Interactive comment on “Development of a method of robust rain gauge network optimization based on intensity-duration-frequency results” by A. Chebbi et al.

Authors would like to thank the anonymous reviewers for their interesting questions and remarks and also for providing a bibliographical complement. Please find enclosed our responses.

Figure 1. Location of rain gauges in the study area (Medjerda basin BV3; Northern coast basins BV3 and surrounding basins Meliane Basin BV4; Central Tunisia basins BV6)

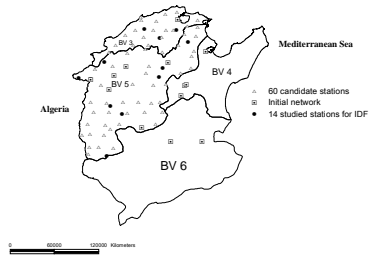
Technical corrections P 14206 line 20 and line 24: 14 is the number of rain gauges for which Data inputs of IDF curves are available (DGRE-ST2i, 2007) while 13 is number of rain gauges of the initial network functioning in March 1973. P 14207: line 8: this reference has been suppressed P14208 line 20: It seems that a point "." is missing in the editorial document. P14209 Montana has been deleted in the new title. Thank you. P14210 line 9: Yes; thank you P 14210 line 19 Yes; thank you P 14226 Fig. 1 ; it has been corrected
